# LEEDS BRADFORD AIRPORT FASI AIRSPACE CHANGE PROPOSAL

**ACP-2021-066**

## Appendix C ACP Stakeholder Feedback Report

**January 2026**

### Question 17: D14 - NW - A

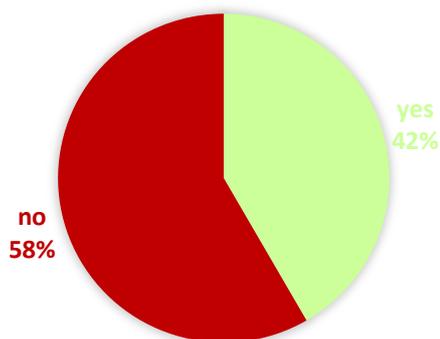
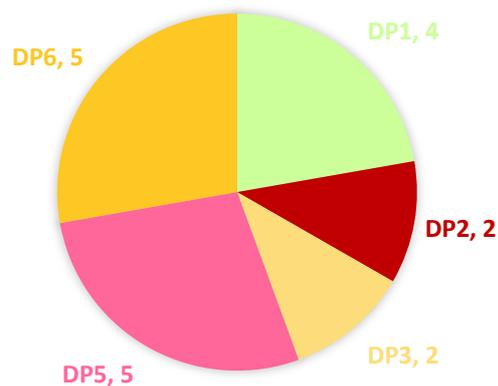
<b>Dales Hang gliding and Paragliding Club (DHPC)</b>	No; DP 3: AMBER: Potential conflict with YDNP. DPs 1, 5 & 6: AMBER. We are unable to make meaningful comment until details of the proposed controlled airspace have been promulgated. The safety implications for users outside CAS cannot be properly assessed at this stage. Until they are, we recommend that these DPs be colour coded amber.;
<b>Wolds Gliding Club</b>	No; The published swathe runs through class G airspace utilised by gliders. Without specific airspace height information we cannot accurately assess the impact of the change. Therefore, we must assume that it may lead to conflict with gliders and fails to meet DP1 DP5 DP6.;
<b>North West Leeds Transport Forum</b>	No;(2) it overflies Headingley, Weetwood, Adel, Alwoodley, Chapel Allerton and Bramhope, (5) requires larger controlled airspace, (6) possible conflict with arrivals.;
<b>Regional Soaring Airspace Group (RSAG)</b>	Same as Q1.

### Question 18: D14-NW-B

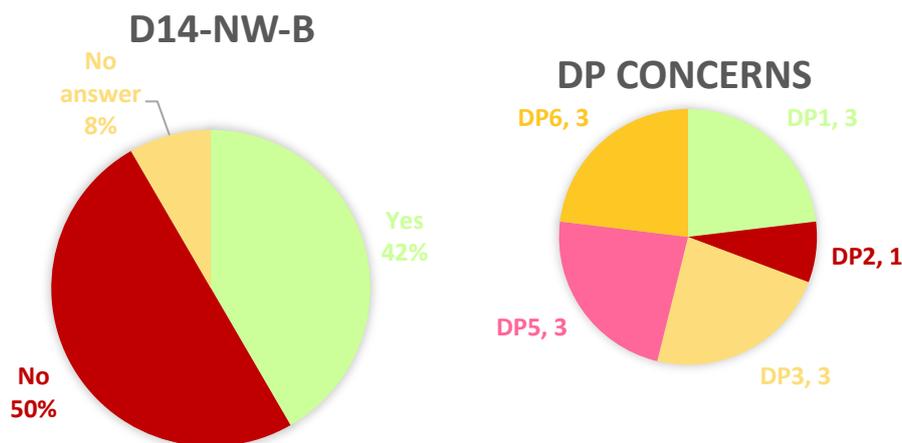
Stakeholder	Feedback
Peak District National Park Authority	No; No recognition under DP3 of overflight of Yorkshire Dales National Park.;
Dales Hang gliding and Paragliding Club (DHPC)	No; DP 3: AMBER: Potential conflict with YDNP. DPs 1, 5 & 6: AMBER. We are unable to make meaningful comment until details of the proposed controlled airspace have been promulgated. The safety implications for users outside CAS cannot be properly assessed at this stage. Until they are, we recommend that these DPs be colour coded amber.;
Wolds Gliding Club	Same as Q1.
North West Leeds Transport Forum	No;(2) it overflies Headingley, Armley and Pudsey;
Regional Soaring Airspace Group (RSAG)	No; DPs 1, 5 & 6 AMBER: Our initial assessment based on our knowledge of the area and LBA's own evaluation. However, we reserve our position until details of any proposed airspace are supplied in order for RSAG members to fully understand the ramifications on other airspace users. ;

City of Bradford Metropolitan District Council	No; DP3 overflies Bradford;

### Question 19: D14-NW-C

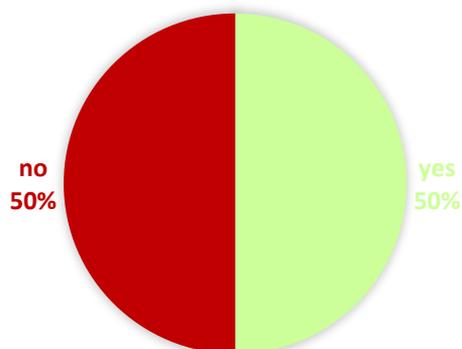
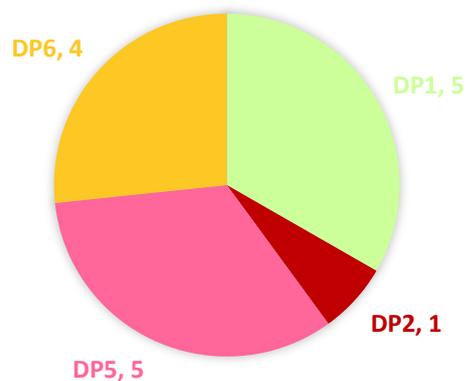
Stakeholder	Feedback
<b>York Gliding Centre, Rufforth Airfield</b>	No;DP1: There is no recognition of the Temporary Reserved Areas for Gliders (TRA(G)) [AIP ENR 6- 64/65] or the Non Secondary Surveillance Radar Gliding Areas [AIP ENR 6-63], or of the likelihood of encountering gliders in mountain wave above FL100 in swathe 14NW- C.
<b>Dales Hang gliding and Paragliding Club (DHPC)</b>	No; DPs 1, 5 & 6: AMBER. We are unable to make meaningful comment until details of the proposed controlled airspace have been promulgated. The safety implications for users outside CAS cannot be properly assessed at this stage. Until they are, we recommend that these DPs be colour coded amber.;
<b>Wolds Gliding Club</b>	No; The published swathe runs through class G airspace utilised by gliders. Without specific airspace height information we cannot accurately assess the impact of the change. Therefore, we must assume that it may lead to conflict with gliders and fails to meet DP1 DP5 DP6.;

### Question 20: D14-NW-D

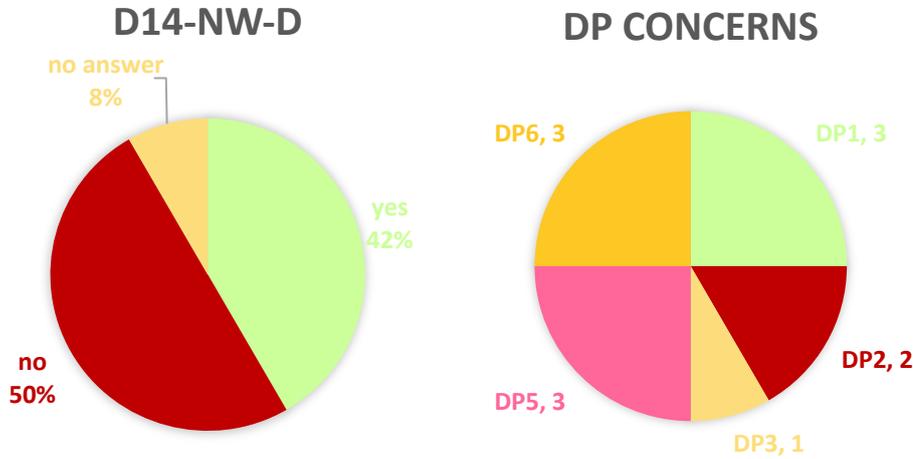
Stakeholder	Feedback
Dales Hang gliding and Paragliding Club (DHPC)	No; DPs 1, 5 & 6: AMBER. We are unable to make meaningful comment until details of the proposed controlled airspace have been promulgated. The safety implications for users outside CAS cannot be properly assessed at this stage. Until they are, we recommend that these DPs be colour coded amber.;
Wolds Gliding Club	No; The published swathe runs through class G airspace utilised by gliders. Without specific airspace height information, we cannot accurately assess the impact of the change. Therefore, we must assume that it may lead to conflict with gliders and fails to meet DP1 DP5 DP6.;
North West Leeds Transport Forum	No;(2) it overflies Headingley, Burley, Armley and Wortley;
Regional Soaring Airspace Group (RSAG)	Same as Q1.
City of Bradford Metropolitan District Council	No;DP3 overflies Bradford;

### Question 21: D14-NE-A

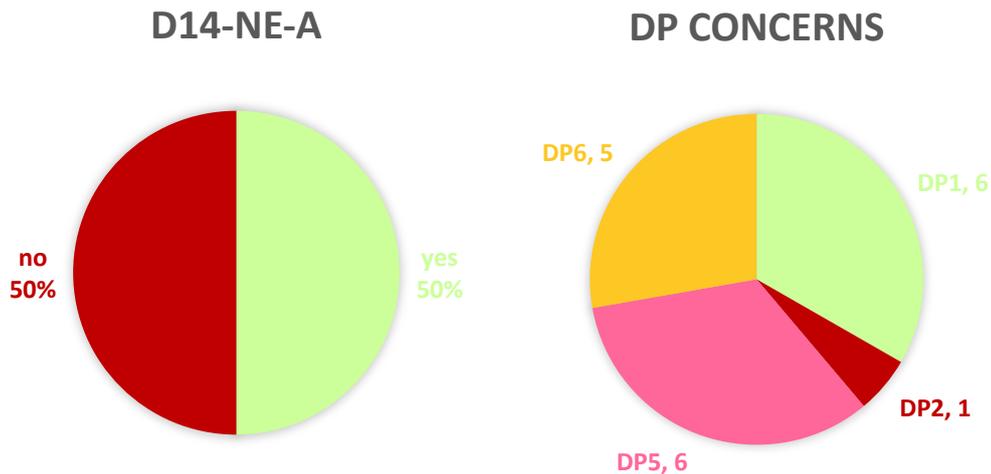
recommend that these DPs be colour coded amber.;
<b>Wolds Gliding Club</b>	No; The published swathe runs through class G airspace utilised by gliders. Without specific airspace height information we cannot accurately assess the impact of the change. Therefore, we must assume that it may lead to conflict with gliders and fails to meet DP1 DP5 DP6.;
<b>North West Leeds Transport Forum</b>	No;(2) it overflies Headingley, Weetwood, Adel, Alwoodley, Chapel Allerton and Bramhope, (5) requires larger controlled airspace;
<b>Regional Soaring Airspace Group (RSAG)</b>	No;DPs 1, 5 & 6 RED: Our initial assessment based on our knowledge of the area and LBA's own evaluation. Swathe 14NE-A covers an AIGA (Area of Intense Gliding Activity) in all soaring conditions, whereby gliders can be operating in thermals up to cloud base and in mountain wave above FL1000. In addition, RAF and other jets operate from RAF Leeming in this area, as well as transiting military traffic. The Temporary Reserved Areas for Gliders (TRA(G)) [AIP ENR 6-64/65] and the Non-Secondary Surveillance Radar Gliding Areas [AIP ENR 6- 63] are not acknowledged. Accordingly, we reserve our position until details of any proposed airspace are supplied in order for RSAG members to fully understand the ramifications on other airspace users ;

### Question 22: D14-NE-B

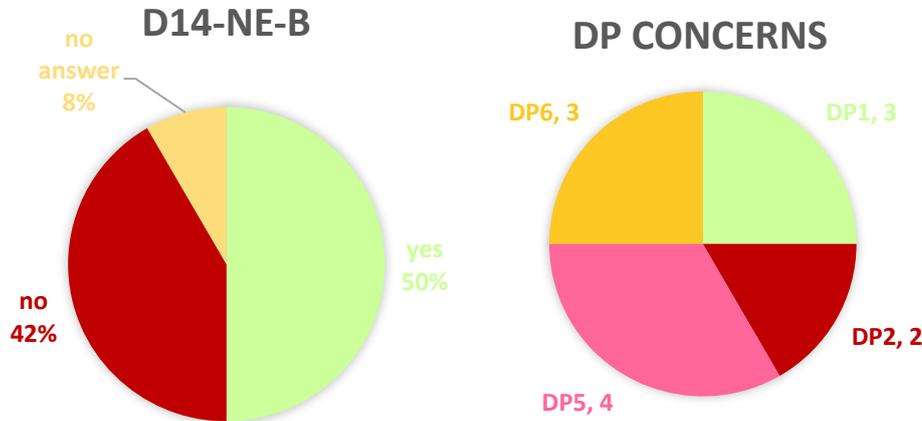
Stakeholder	Feedback
Dales Hang gliding and Paragliding Club (DHPC)	No; DPs 1, 5 & 6: AMBER. We are unable to make meaningful comment until details of the proposed controlled airspace have been promulgated. The safety implications for users outside CAS cannot be properly assessed at this stage. Until they are, we recommend that these DPs be colour coded amber.;
Wolds Gliding Club	No; The published swathe runs through class G airspace utilised by gliders. Without specific airspace height information we cannot accurately assess the impact of the change. Therefore, we must assume that it may lead to conflict with gliders and fails to meet DP1 DP5 DP6.;
North West Leeds Transport Forum	No; (2) it overflies Headingley, Burley, Armley and Wortley;
Regional Soaring Airspace Group (RSAG)	Same as Q1.

### Question 23: D14-NE-C

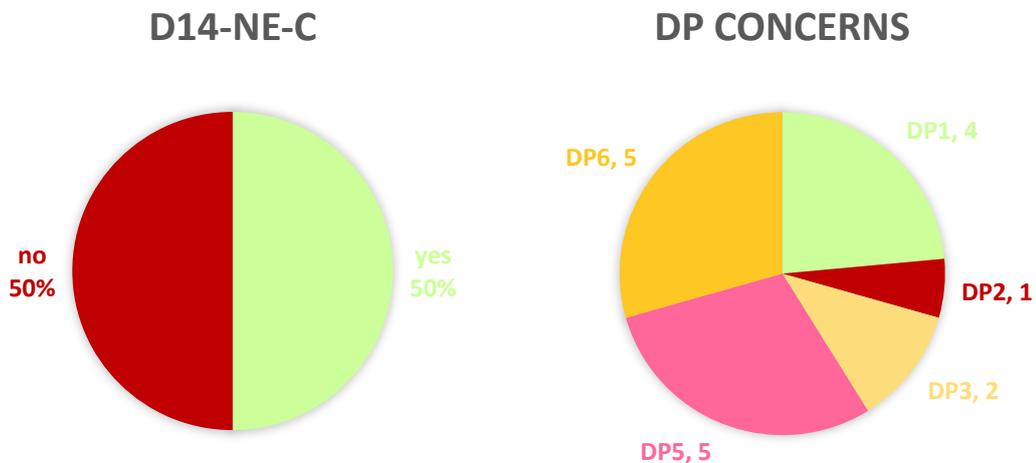
Stakeholder	Feedback
<b>Yorkshire Dales National Park</b>	No recognition under DP3 of overflight of Yorkshire Dales National Park; No
<b>Dales Hang gliding and Paragliding Club (DHPC)</b>	No; DPs 1, 5 & 6: AMBER. We are unable to make meaningful comment until details of the proposed controlled airspace have been promulgated. The safety implications for users outside CAS cannot be properly assessed at this stage. Until they are, we recommend that these DPs be colour coded amber.;
<b>Wolds Gliding Club</b>	No; The published swathe runs through class G airspace utilised by gliders. Without specific airspace height information we cannot accurately assess the impact of the change. Therefore, we must assume that it

### Question 24: D14-NE-D

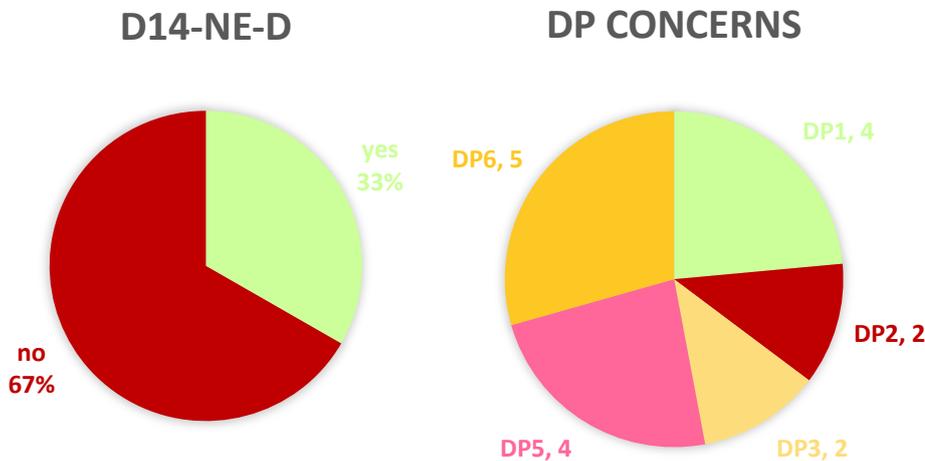
Stakeholder	Feedback
<b>Yorkshire Dales National Park</b>	No recognition under DP3 of overflight of Yorkshire Dales National Park; No
<b>Dales Hang gliding and Paragliding Club (DHPC)</b>	No; DPs 1, 5 & 6: AMBER. We are unable to make meaningful comment until details of the proposed controlled airspace have been promulgated. The safety implications for users outside CAS cannot be properly assessed at this stage. Until they are, we recommend that these DPs be colour coded amber.;
<b>Wolds Gliding Club</b>	No; The published swathe runs through class G airspace utilised by gliders. Without

specific airspace height information we cannot accurately assess the impact of the change. Therefore, we must assume that it may lead to conflict with gliders and fails to meet DP1 DP5 DP6.;
<b>North West Leeds Transport Forum</b>	No;(2) it overflies south west Leeds, Headingley and Pudsey (6) possible conflict with arrivals.;
<b>Regional Soaring Airspace Group (RSAG)</b>	Same as Q1.
<b>City of Bradford Metropolitan District Council</b>	No; DP3 overflies Bradford;
<b>British Gliding Association</b>	Same as Q1.
<b>Bramhope &amp; Carlton Parish Council</b>	DP2 - the comment on D14-NE-A "Overflight of populated areas" must apply to D14-NE-D

### Question 25: D14-NE-E

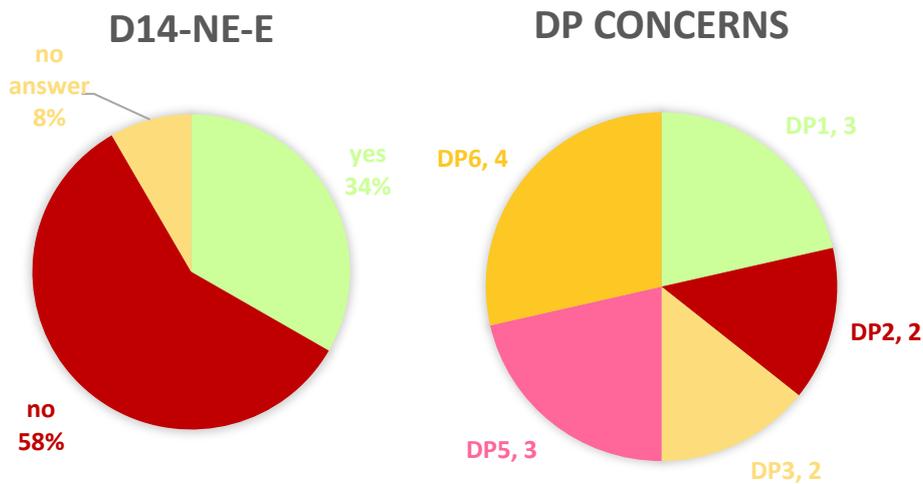
Stakeholder	Feedback
<b>Yorkshire Dales National Park</b>	No recognition under DP3 of overflight of Yorkshire Dales National Park; No
<b>Dales Hang gliding and Paragliding Club (DHPC)</b>	No; DPs 1, 5 & 6: AMBER. We are unable to make meaningful comment until details of the proposed controlled airspace have been

### Question 26: D14-SE-A

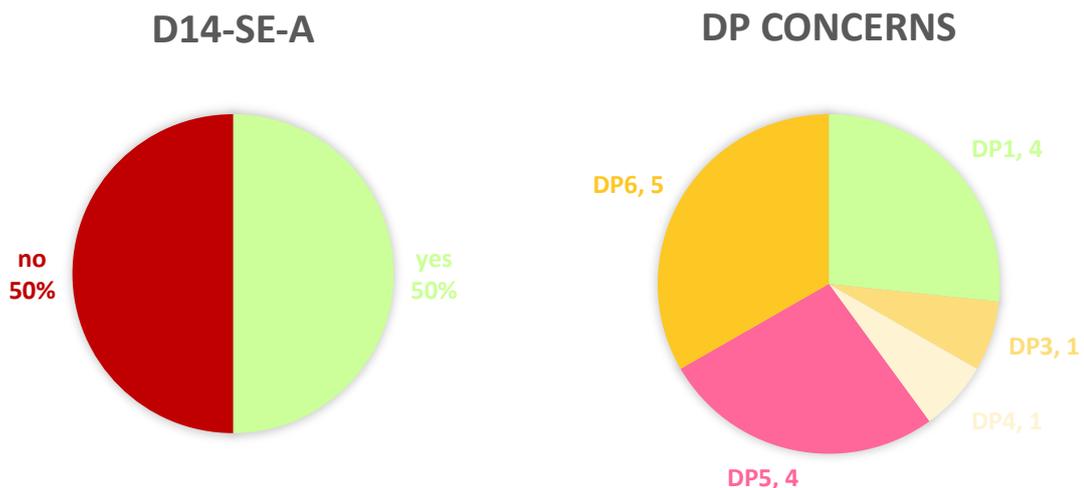
<b>Yorkshire Gliding Centre, Rufforth Airfield</b>	No;DP6: It is not clear how swathe 14SE-A will synchronise with the DSA CTA and the Yorkshire CTA that abuts it as no flight level information is given;
<b>Yorkshire Dales National Park</b>	No recognition under DP3 of overflight of Yorkshire Dales National Park; No
<b>Dales Hang gliding and Paragliding Club (DHPC)</b>	No;DP4: AMBER: Extra track miles. DPs 1, 5 & 6: AMBER. We are unable to make meaningful comment until details of the proposed controlled airspace have been promulgated. The safety implications for users outside CAS cannot be properly assessed at this stage. Until they are, we recommend that these DPs be colour coded amber.;
<b>Wolds Gliding Club</b>	No; The published swathe runs through class G airspace utilised by gliders. Without specific airspace height information we cannot accurately assess the impact of the change. Therefore, we must assume that it may lead to conflict with gliders and fails to meet DP1 DP5 DP6.;

on gliding. We refer you to the response of the Regional Soaring Airspace Group.;

### Question 27: D14-SE-B

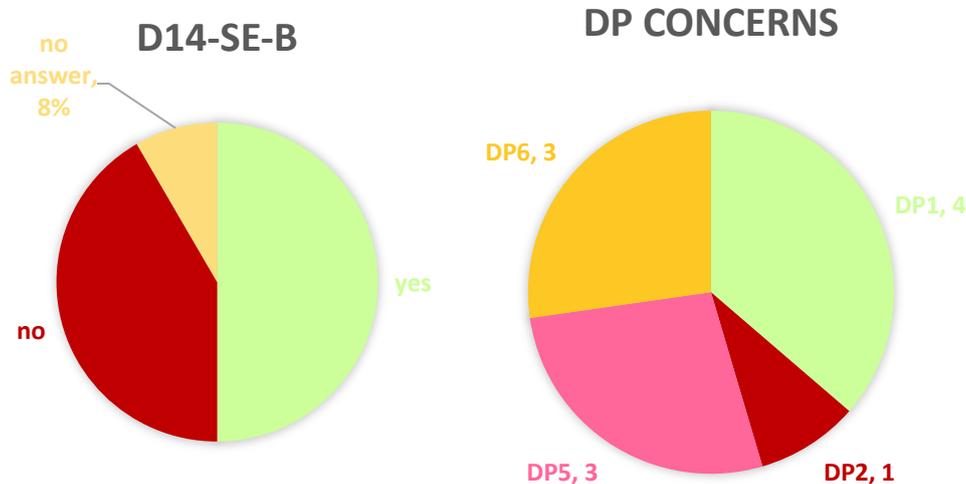
Stakeholder	Feedback
Yorkshire Gliding Centre, Rufforth Airfield	No; DP1: It is also not clear if swathe 14SE-B & D will affect the agreement between DSA and the BGA to raise the floor of DSA CTA 8 & 9 in thermic soaring conditions (The 'Upton Corridor'). Swathes 14SE C & D also overfly busy GA and gliding airfields with gliders likely to be encountered up FL195 and potentially (under AIP ENR 6-64/65) much higher along much of each swathe.;
Dales Hang gliding and Paragliding Club (DHPC)	No; DPs 1, 5 & 6: AMBER. We are unable to make meaningful comment until details of the proposed controlled airspace have been promulgated. The safety implications for users outside CAS cannot be properly assessed at this stage. Until they are, we recommend that these DPs be colour coded amber.;
Wolds Gliding Club	Same as Q1.
North West Leeds Transport Forum	No;(2) it overflies Leeds;
Regional Soaring Airspace Group (RSAG)	No;DPs 1, 5 & 6 RED: Our initial assessment based on our knowledge of the area and

### Question 28: D14-SE-C

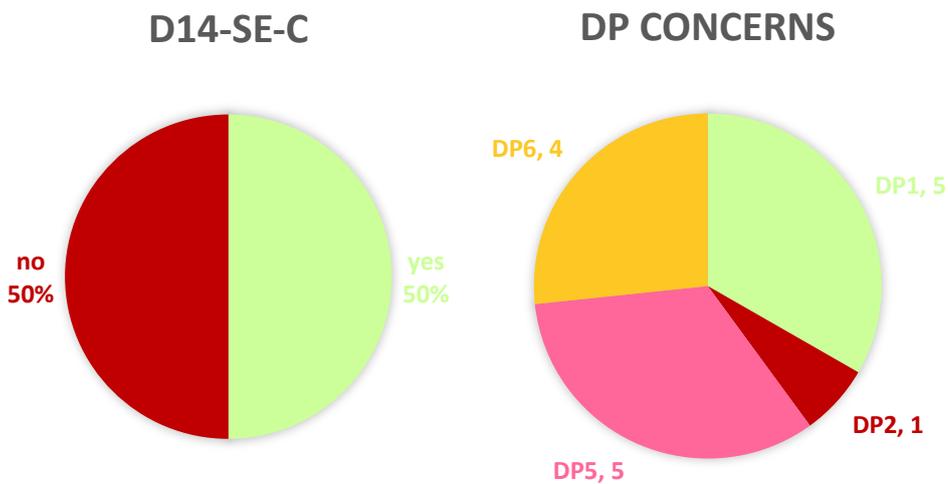
<p>busy GA and gliding airfields with gliders likely to be encountered up FL195 and potentially (under AIP ENR 6-64/65) much higher along much of each swathe.;</p>
<p><b>Dales Hang gliding and Paragliding Club (DHPC)</b></p>	<p>No; DPs 1, 5 &amp; 6: AMBER. We are unable to make meaningful comment until details of the proposed controlled airspace have been promulgated. The safety implications for users outside CAS cannot be properly assessed at this stage. Until they are, we recommend that these DPs be colour coded amber.;</p>
<p><b>Wolds Gliding Club</b></p>	<p><i>Repeated Feedback.</i></p>
<p><b>North West Leeds Transport Forum</b></p>	<p>No;(2) it overflies even more of Leeds than D14- SE-B, (5) requires larger controlled airspace;</p>
<p><b>Regional Soaring Airspace Group (RSAG)</b></p>	<p>No;DPs 1,5 &amp; 6 RED: Our initial assessment based on our knowledge of the area and LBA's own evaluation. In addition, will swathes 14SE-C impact the Upton Corridor Agreement existing between the BGA and DSA whereby, in suitable weather, the floors of DSA CTA 8 &amp; 9 are raised to facilitate transiting North/South (and vice versa) cross country gliders. Furthermore, swathe 14SE-C overflies busy gliding and GA areas and is an AIGA Accordingly, we reserve our position until details of any proposed airspace are supplied in order for RSAG members to fully understand the ramifications on other airspace users. ;</p>

### Question 30: D14-S&W-A

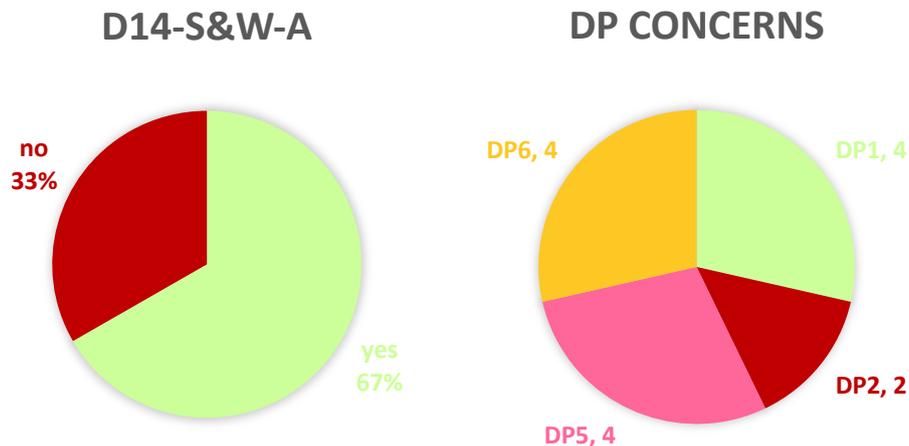
Stakeholder	Feedback
Dales Hang gliding and Paragliding Club (DHPC)	No; DP9: AMBER: Extra track miles. DPs 1, 5 & 6: AMBER. We are unable to make meaningful comment until details of the proposed controlled airspace have been promulgated. The safety implications for users outside CAS cannot be properly assessed at this stage. Until they are, we recommend that these DPs be colour coded amber.;

### Question 31: D14-S&W-B

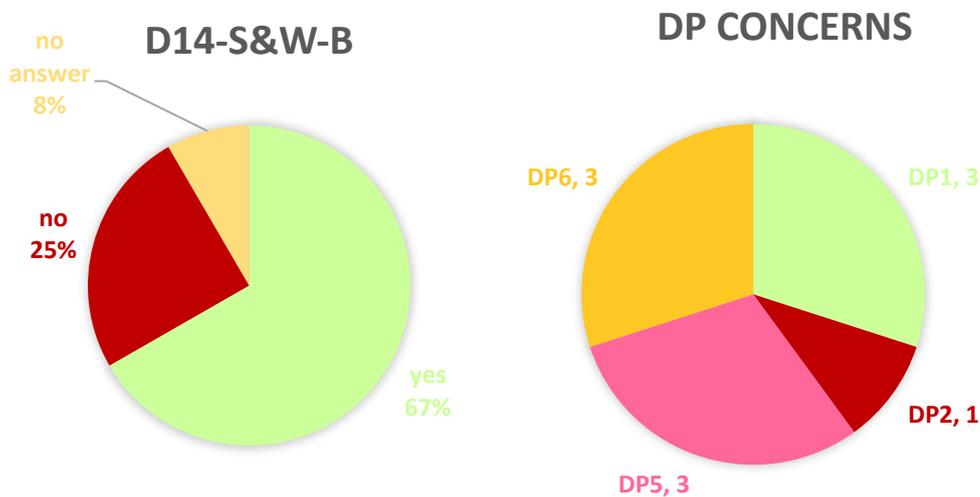
Stakeholder	Feedback
<b>Dales Hang gliding and Paragliding Club (DHPC)</b>	No; DPs 1, 5 & 6: AMBER. We are unable to make meaningful comment until details of the proposed controlled airspace have been promulgated. The safety implications for users outside CAS cannot be properly assessed at this stage. Until they are, we recommend that these DPs be colour coded amber.;
<b>Wolds Gliding Club</b>	<i>Repeated Feedback.</i>
<b>North West Leeds Transport Forum</b>	Yes;but (2) it overflies Bramley and Pudsey ;

### Question 32: D14-S&W-C

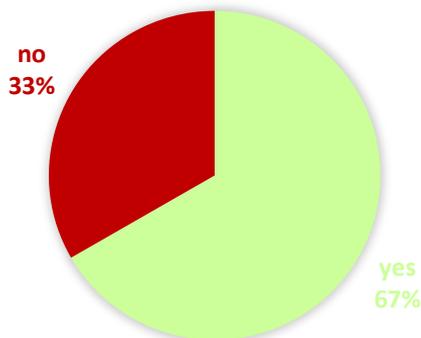
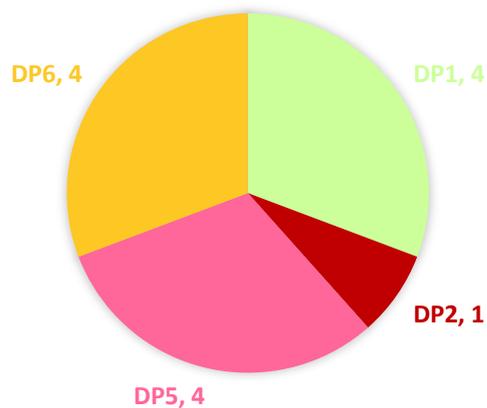
Stakeholder	Feedback
Dales Hang gliding and Paragliding Club (DHPC)	No; DPs 1, 5 & 6: AMBER. We are unable to make meaningful comment until details of the proposed controlled airspace have been promulgated. The safety implications for users outside CAS cannot be properly assessed at this stage. Until they are, we recommend that these DPs be colour coded amber.;
Wolds Gliding Club	<i>Repeated Feedback.</i>
North West Leeds Transport Forum	Yes; but (2) it overflies Bramley and Pudsey ;
Regional Soaring Airspace Group (RSAG)	No; DPs 1, 5 & 6 AMBER: Our initial assessment based on our knowledge of the area and LBA's own evaluation. However, we reserve our position until details of any proposed airspace are supplied in order for RSAG members to fully understand the ramifications on other airspace users. ;
British Gliding Association	No; It is difficult to ascertain how DPs 1, 5 and 6 have been applied as there does not

appear to be any airspace design proposed at stage 2 so any impact on us as a stakeholder is unclear. Lowering or increasing controlled airspace generally has a detrimental impact on gliding. We refer you to the response of the Regional Soaring Airspace Group.;

### Question 33: D14-S&W-D

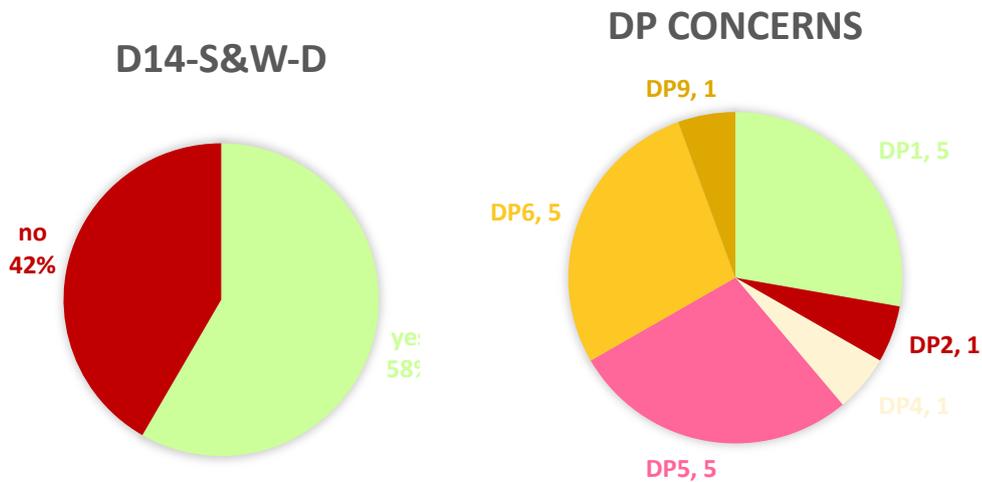
Stakeholder	Feedback
Dales Hang gliding and Paragliding Club (DHPC)	No; DPs 1, 5 & 6: AMBER. We are unable to make meaningful comment until details of the proposed controlled airspace have been promulgated. The safety implications for users outside CAS cannot be properly assessed at this stage. Until they are, we recommend that these DPs be colour coded amber.;
Wolds Gliding Club	No; The published swathe runs through class G airspace utilised by gliders. Without specific airspace height information we cannot accurately assess the impact of the change. Therefore, we must assume that it
